LEESTON PLAN CHANGE - RFI RESPONSE

Thank you for your letter dated 19 September requesting further information regarding Plan Change PC190062: Private Plan Change Leeston. Baseline Group has prepared the following response.

Leeston Plan Change

Appendix 4: Outline Development Plan

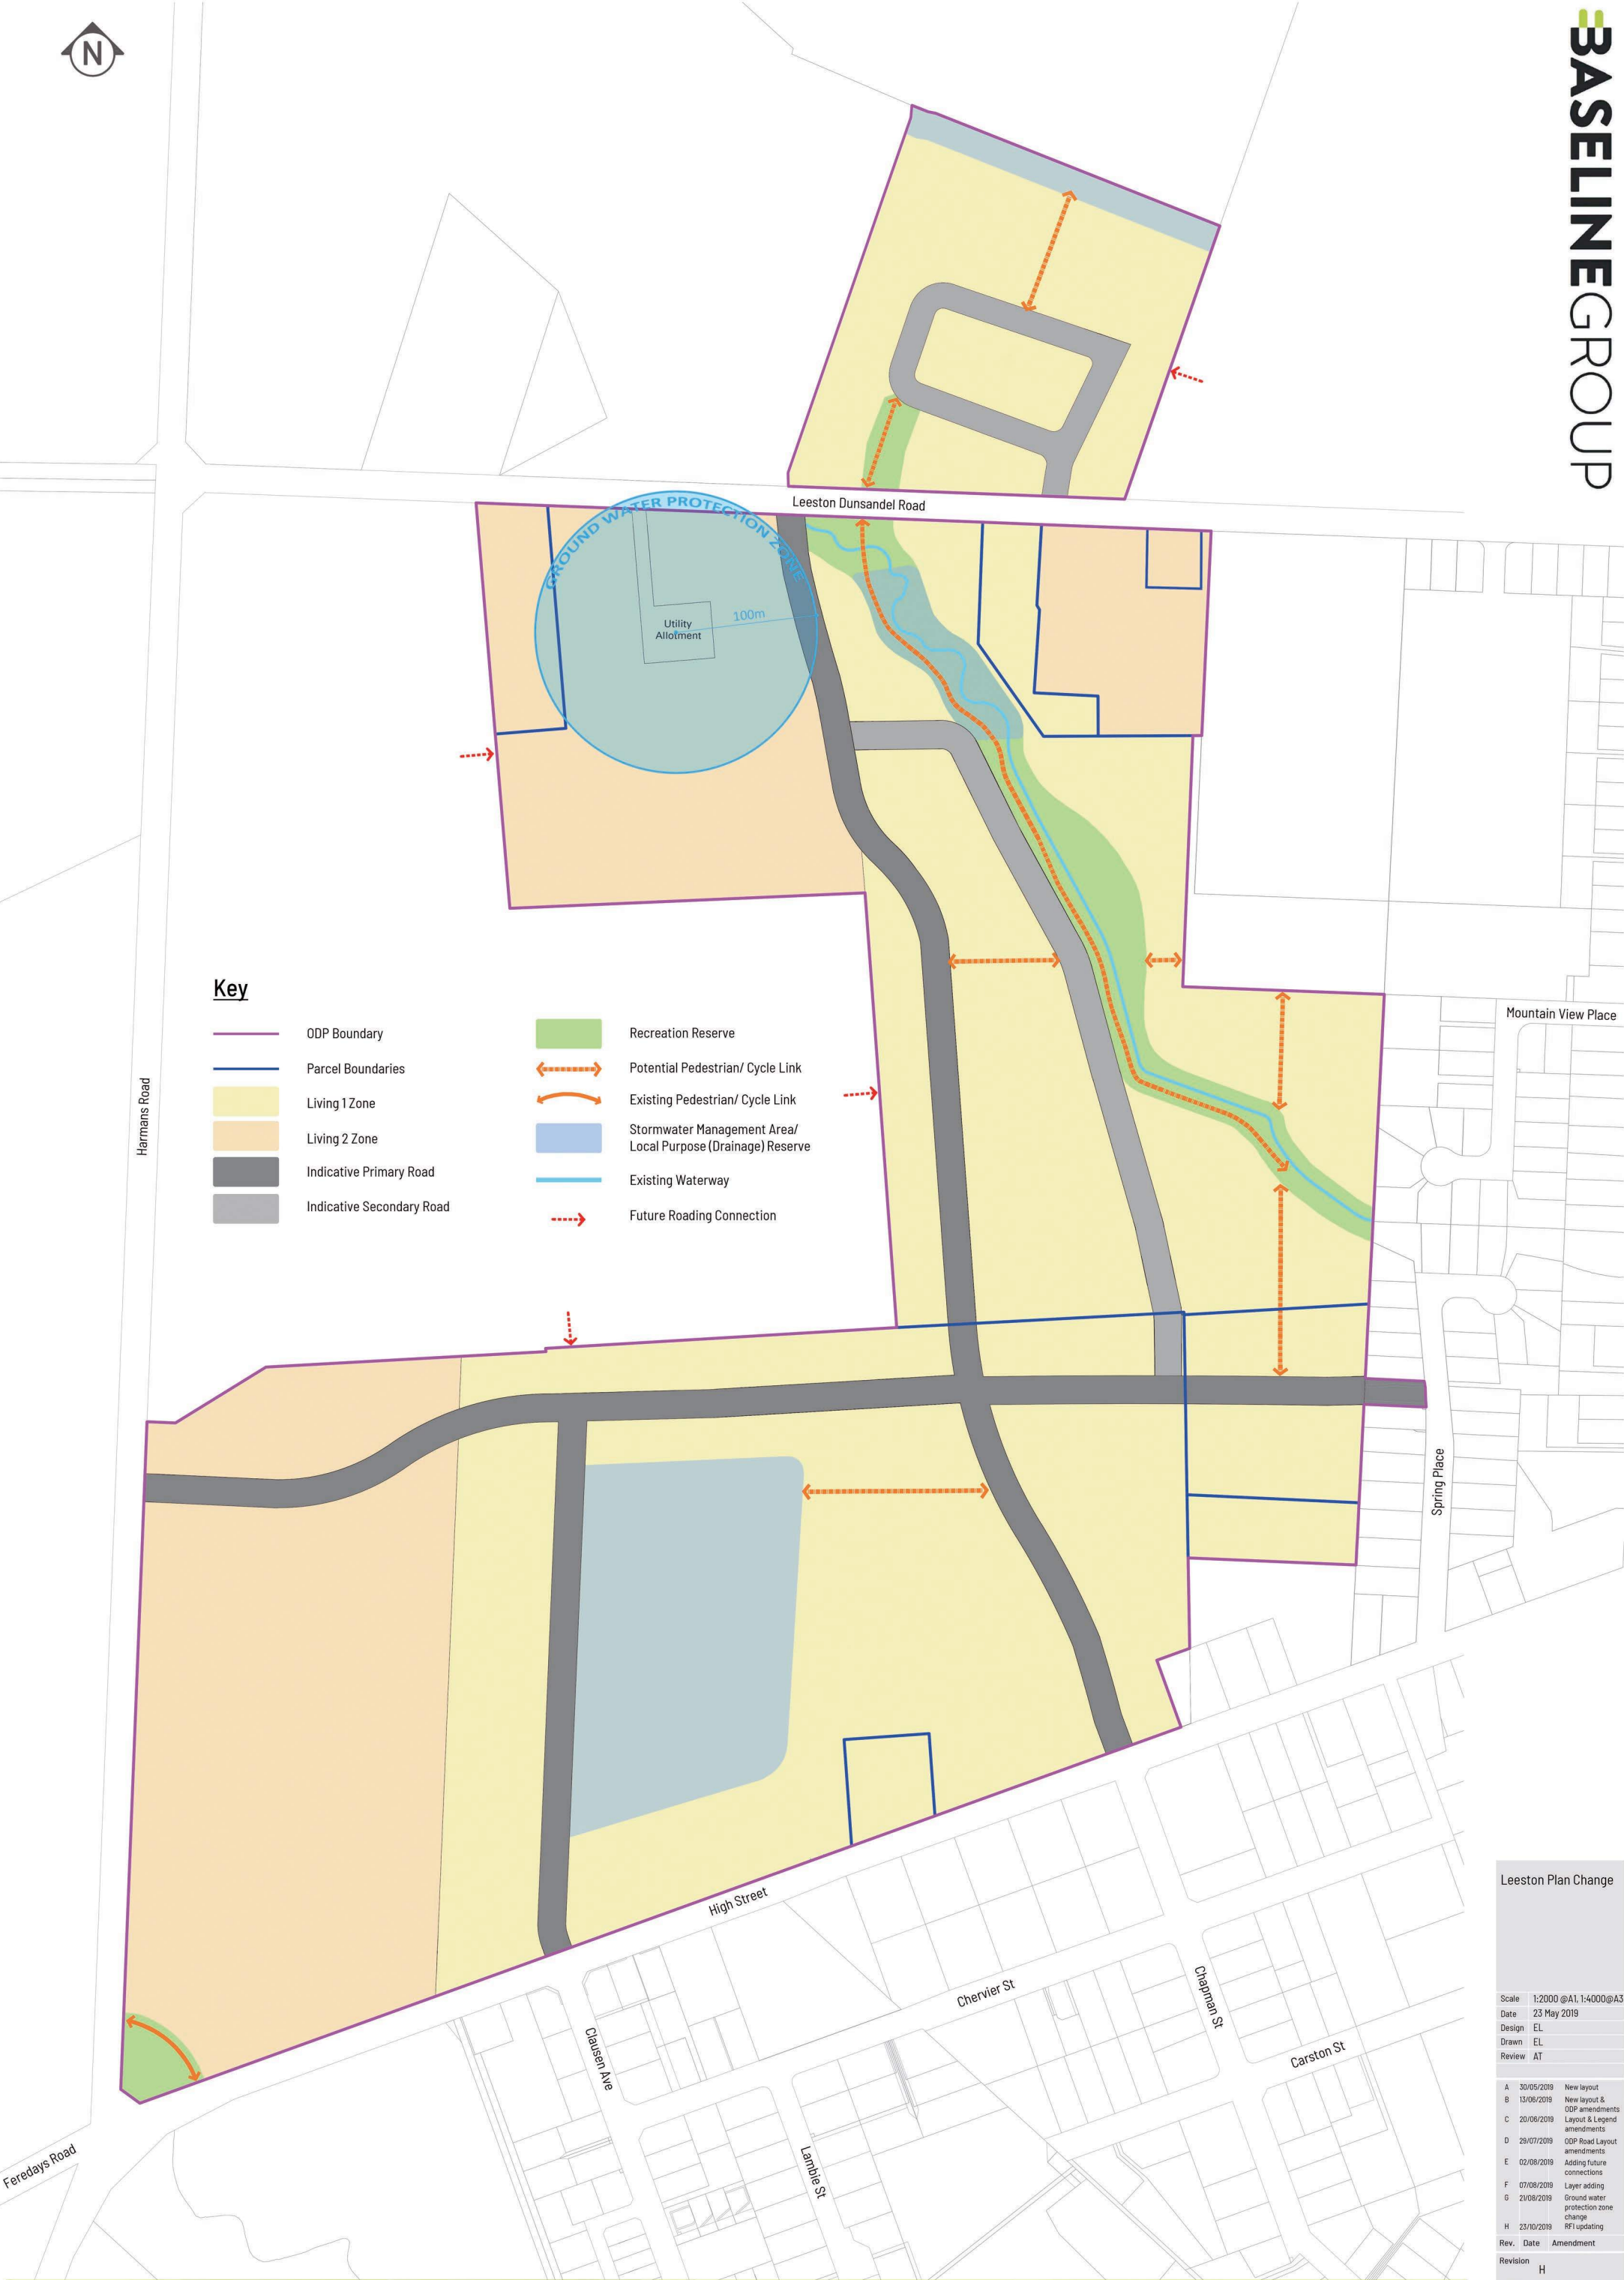
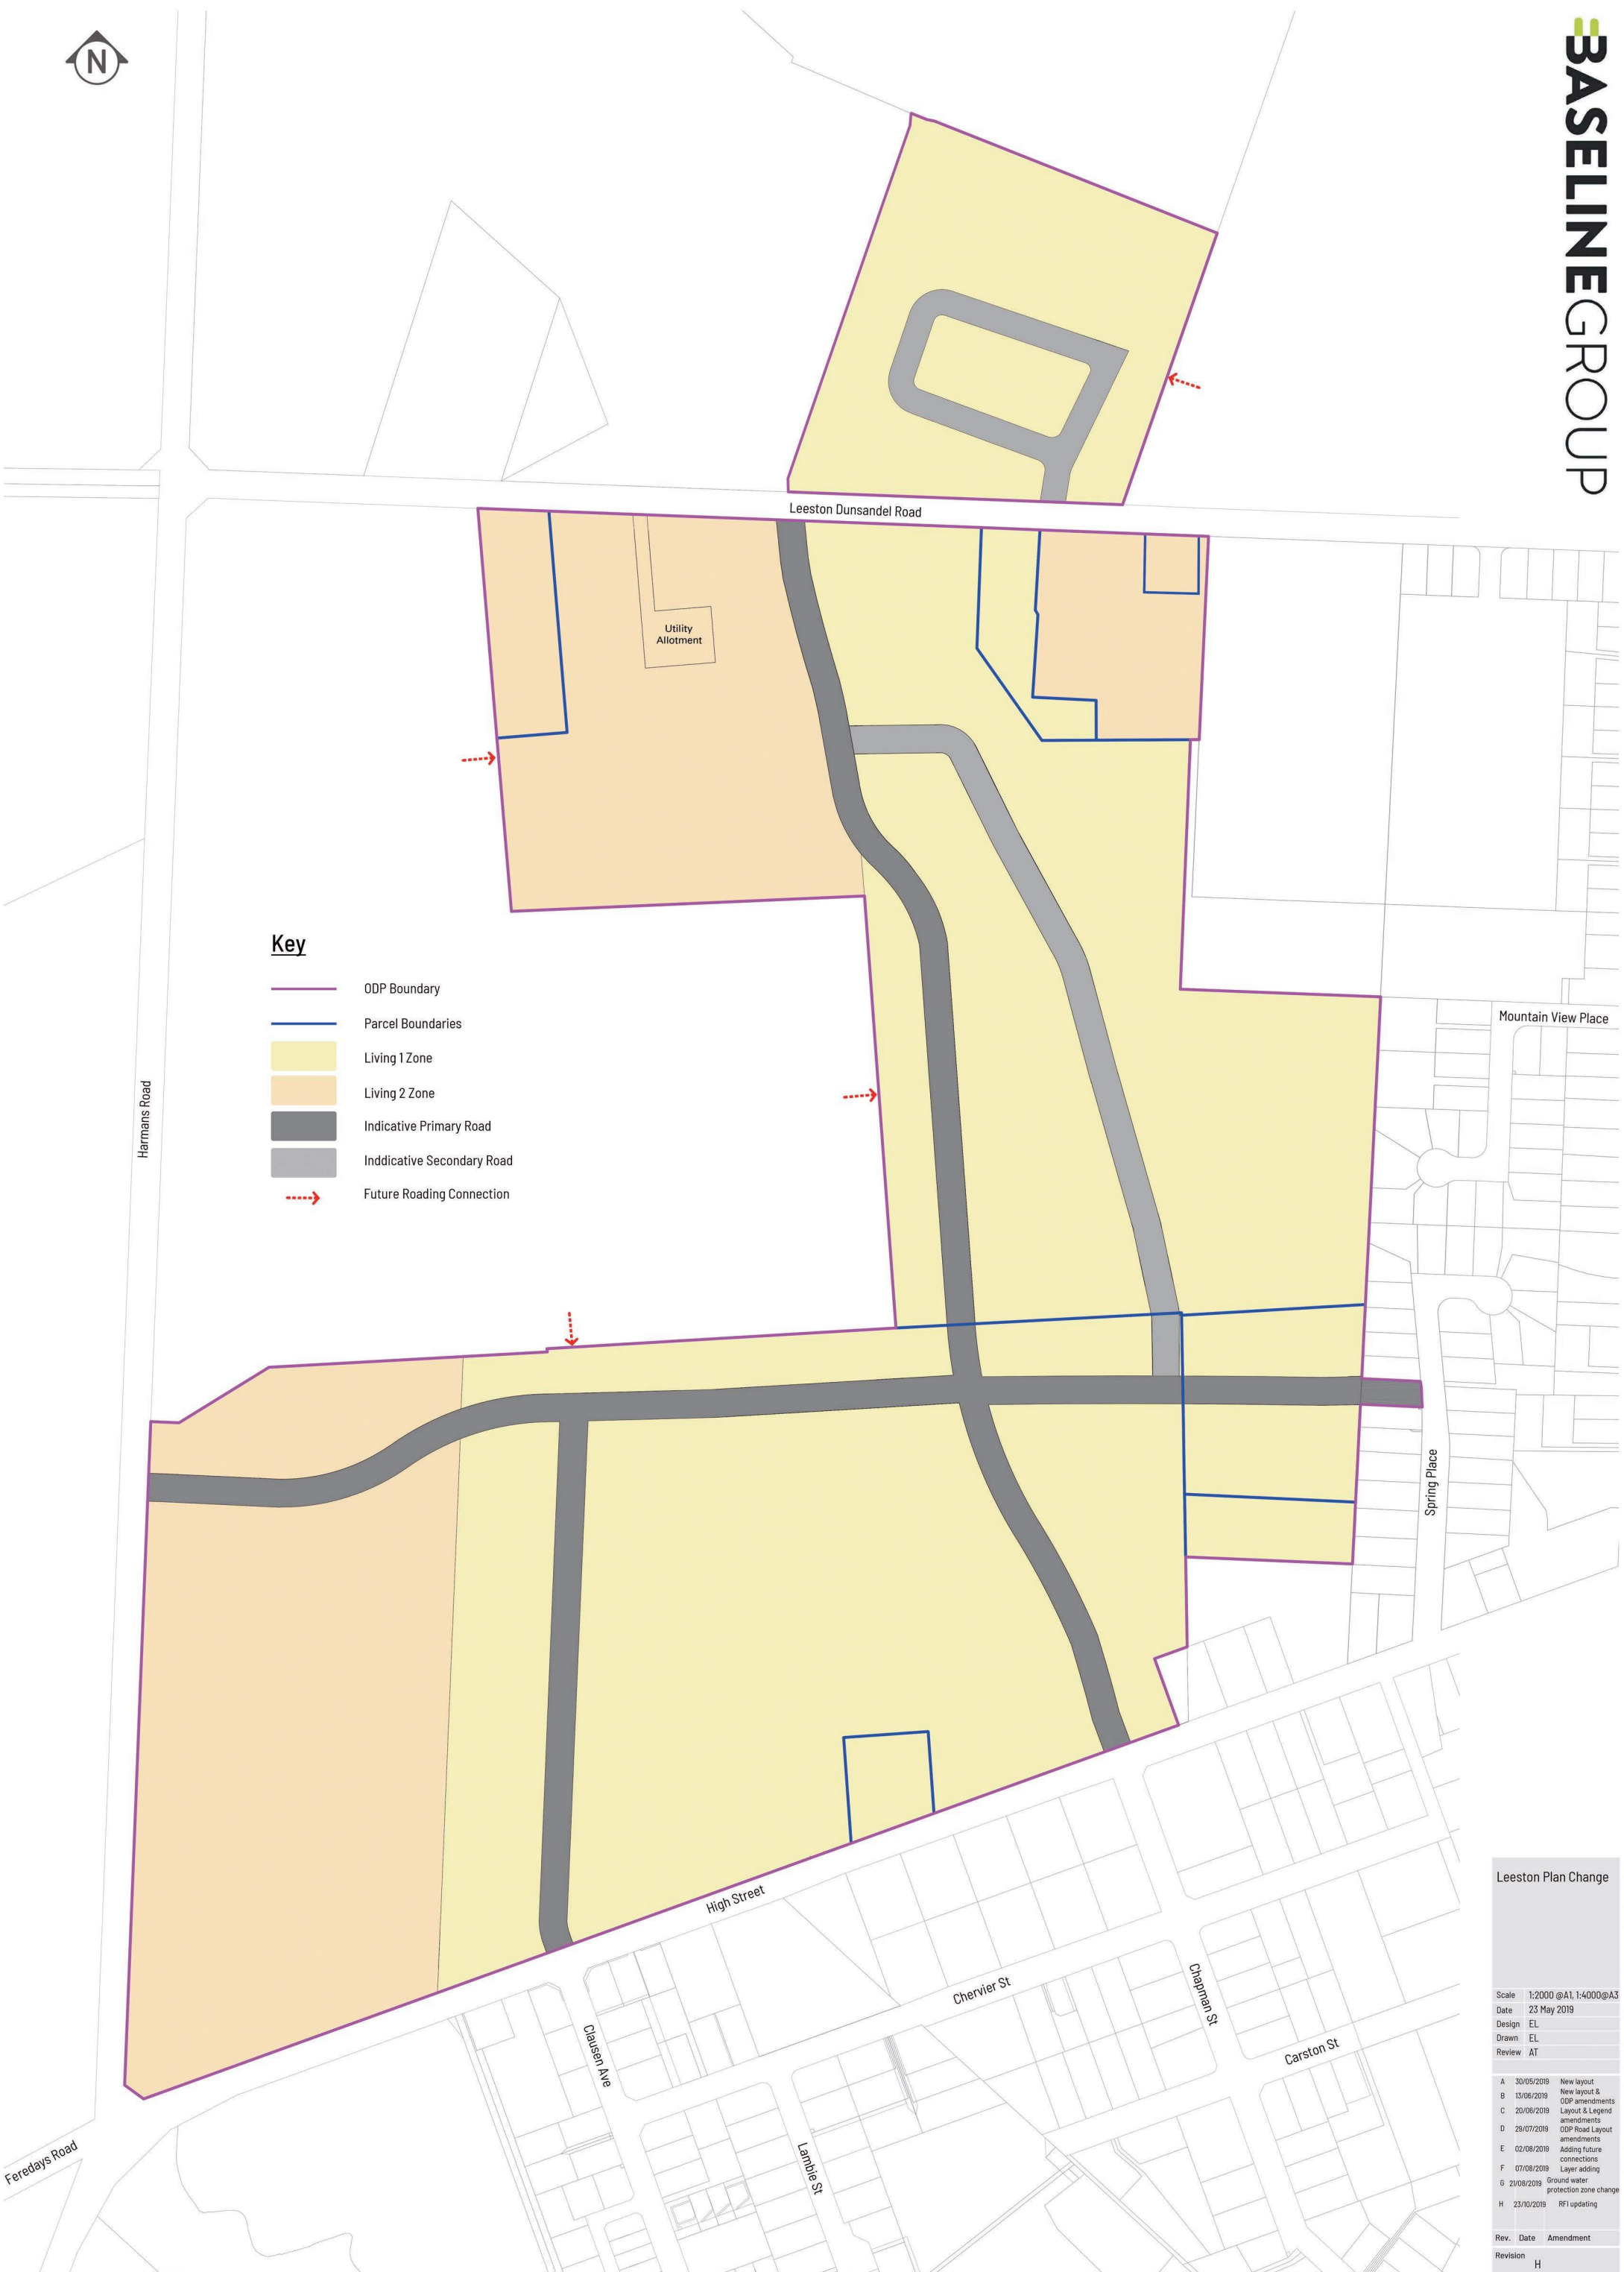
12. As highlighted in yellow below, the ODP should show a specific pedestrian/cycle link along the main reserve/water course alignment. The ODP should also show a pedestrian/cycle link from the northern part of the to the future stormwater reserve area along the northern boundary of the site.

17. There are small inconsistencies between the overall ODP and the transport network in terms of the pedestrian/cycle links. Please resolve these. It is noted that a continuous alignment is preferred.

19. The names of the surrounding roads should also be shown on the ODP.

22. The ODP should be amended to reflect any matters raised in the points above, particularly regarding roading and reserves.

These have been added to the ODP and a revised copy of the ODP is attached in Appendix 4.

The ODP has been amended to resolve the inconsistencies between the overall ODP and the transport network plan and is attached in Appendix 4.

Road names have been added to the ODP plans in Appendix 4.

The ODP plans have been amended and are attached to this letter in Appendix 4.
